### APPEAL SUMMARY

**Status:** Decision Rendered - Reconsideration of ID 26419

<b>Appeal ID:</b> 26449	<b>Project Address:</b> 1784 NW Northrup St
<b>Hearing Date:</b> 1/26/22	<b>Appellant Name:</b> Tiffonie Carroll
<b>Case No.:</b> B-008	<b>Appellant Phone:</b> 5034847745
<b>Appeal Type:</b> Building	<b>Plans Examiner/Inspector:</b> John Cooley
<b>Project Type:</b> commercial	<b>Stories:</b> 7 <b>Occupancy:</b> B, M, R-2, S-2 <b>Construction Type:</b> Type I-A and Type III-A
<b>Building/Business Name:</b> North 18	<b>Fire Sprinklers:</b> Yes - throughout
<b>Appeal Involves:</b> Erection of a new structure	<b>LUR or Permit Application No.:</b> 20-161043-CO
<b>Plan Submitted Option:</b> pdf [File 1] [File 2] [File 3]	<b>Proposed use:</b> multifamily

### **Omission of fire rated construction of Level 3, Type IIIA roofed trellis: Granted as proposed.**

DRAWING TITLE  
COMPOSITE PLANS - TRELLIS

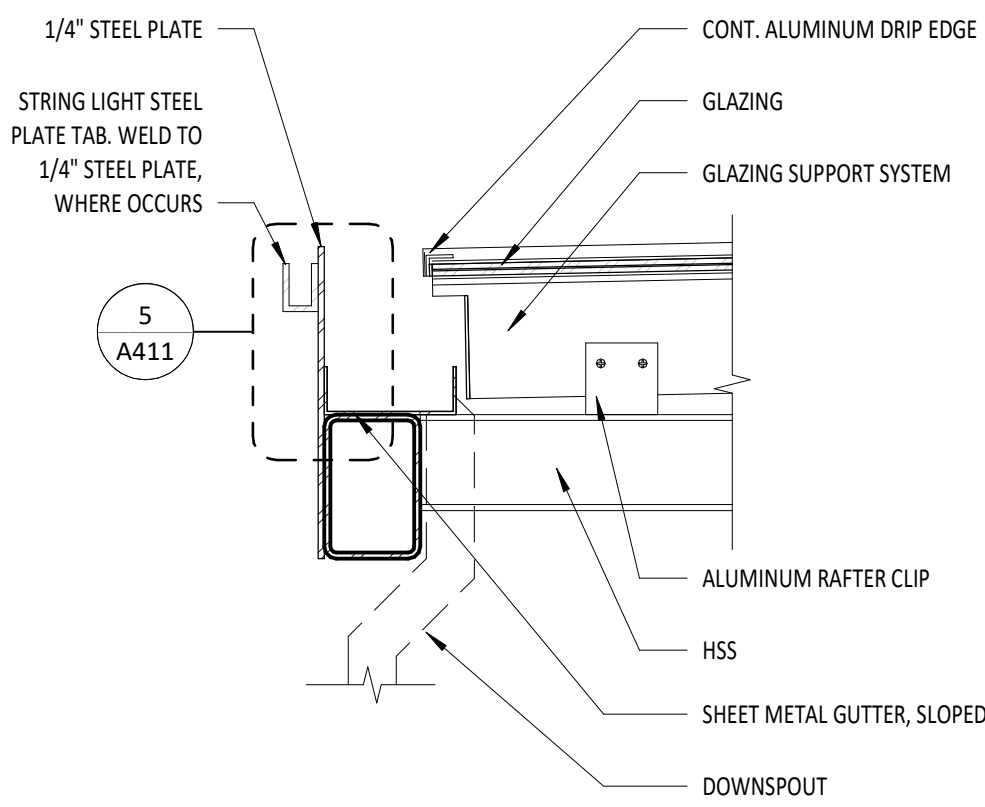
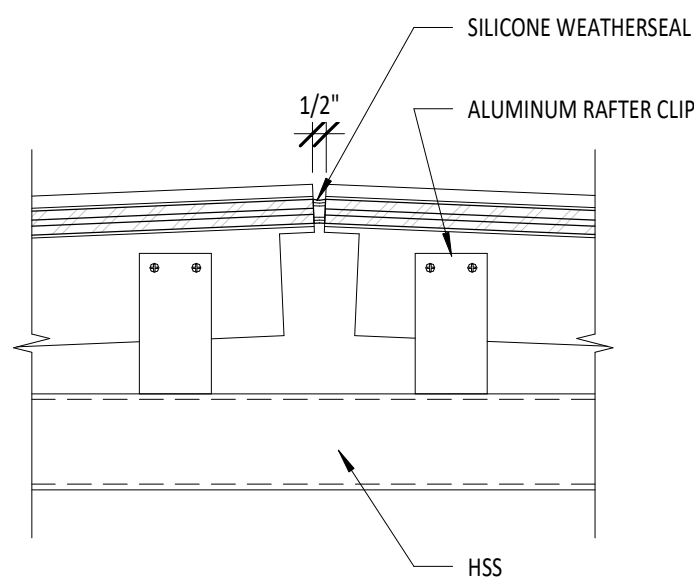
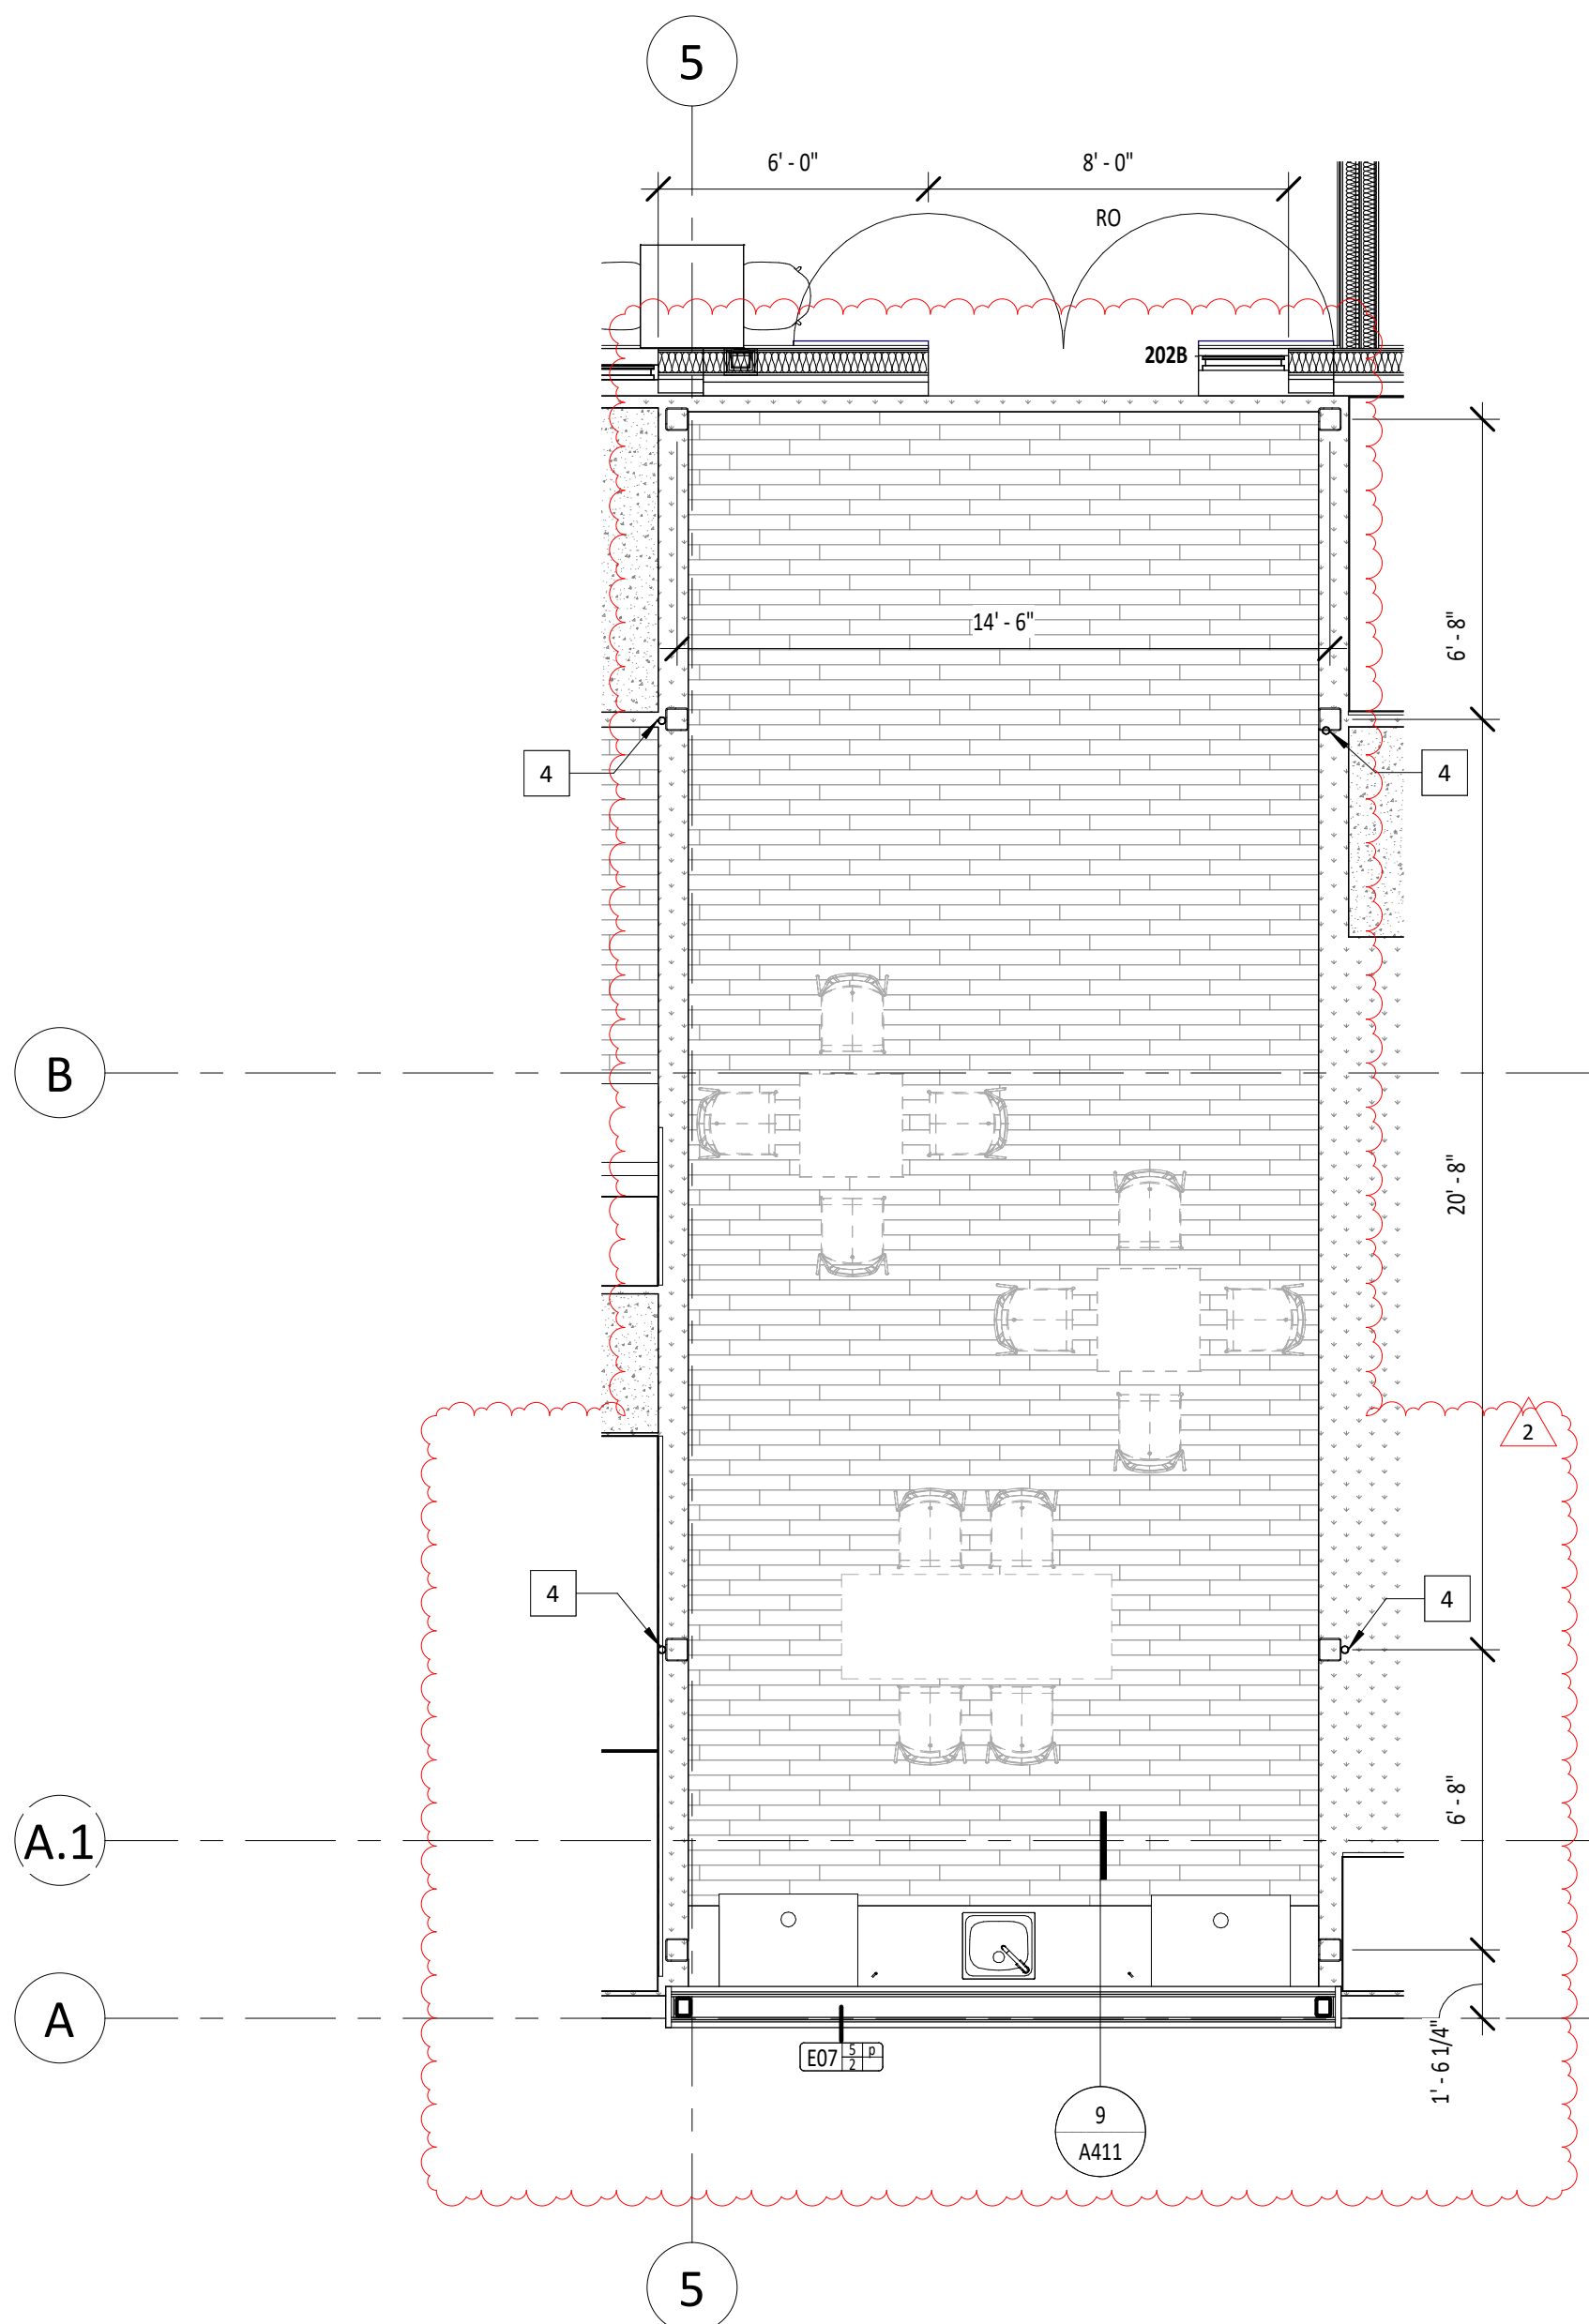
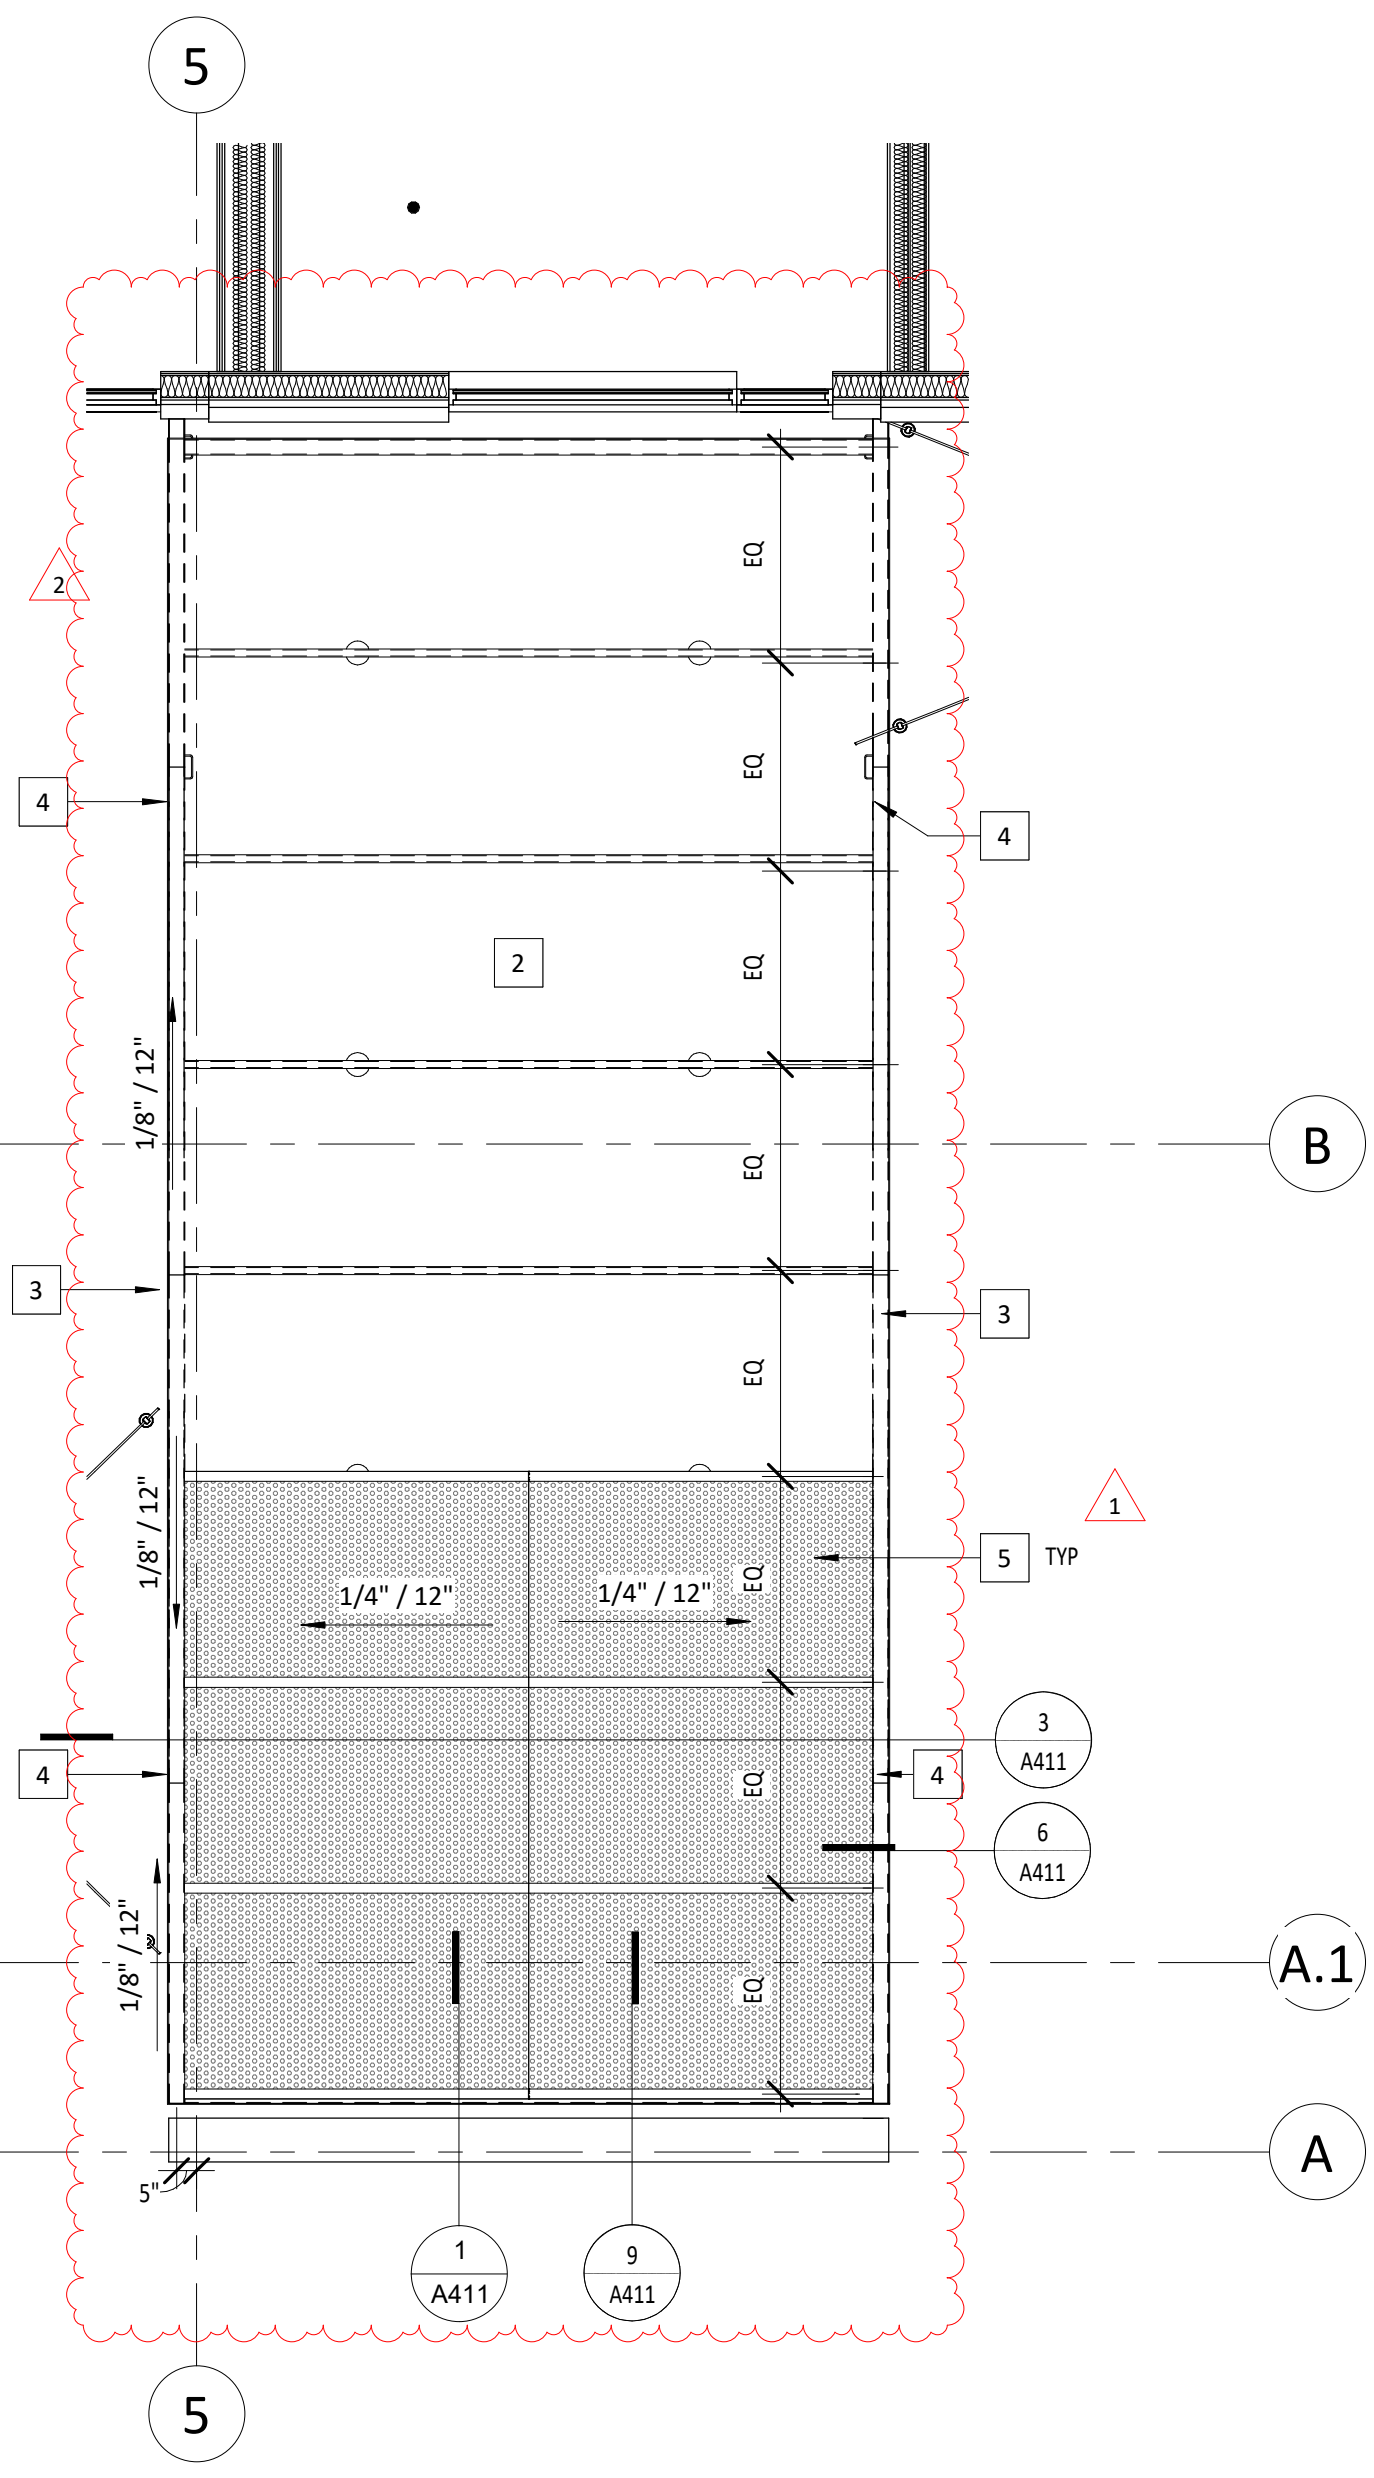
<b>Code Section</b>	2019 OSSC Table 601
<b>Requires</b>	Table 601: Primary structural frame for Type III-A is required to be 1hr construction.
<b>Code Modification or Alternate Requested</b>	We ask that the primary structural frame for the amenity deck trellis not be required to be 1hr construction, and instead to be non-combustible.
<b>Proposed Design</b>	<p>Building Construction at levels 1 &amp; 2 are construction Type I-A. Levels 3 thru 7 are Type III-A. Occupancy at the amenity deck on level 3 is A-3. The building is fully sprinklered. The level 3 deck is 2hr rated concrete with sand and pavers.</p> <p>The trellis canopy structure at level 3 is open on 3 sides, and has a glass canopy for about 165 sf (the entire amenity deck is about 2267 sf). The glass canopy is 10' above finish floor, and is open on 3 sides: total open area is over 400 sf of open area, more than 2.5x the area of the glass canopy. Sprinklers for the trellis are not required nor proposed.</p> <p>The small glass canopy is provided as a rain cover for the bbq's and a few tables so the deck can be useable during inclement weather.</p> <p>The trellis is made of steel and glass (noncombustible), and is supported by HSS 6x6x5/16 columns. There is a 2hr rated wall at the south end of the trellis that extends 2'-6" above the highest point of the glass canopy (only 1hr is required per table 602).</p> <p>The trellis structure is isolated from the building structure and only supports trellis components.</p>

<b>Reason for alternative</b>	Our trellis is not constructed over exterior walls, has no roof deck, nor thermal barriers. It has low risk of heat and smoke containment due to the fact that it is open on 3 sides.

The trellis columns should not be required to be rated because in the event of a fire people will not congregate below the 165sf canopy – they will walk towards the exits and evacuate the deck. There are no walls restricting egress nor smoke at the trellis. We propose protection to the south with a 2hr wall (1hr required) and to construct the trellis and canopy with non-combustible materials. In the event of a fire at the neighboring property the area beneath the trellis will be protected and people can evacuate the amenity deck via the 2 egress paths provided.

The Administrative Appeal Board finds that the information submitted by the appellant demonstrates that the approved modifications or alternate methods are consistent with the intent of the code; do not lessen health, safety, accessibility, life, fire safety or structural requirements; and that special conditions unique to this project make strict application of those code sections impractical.
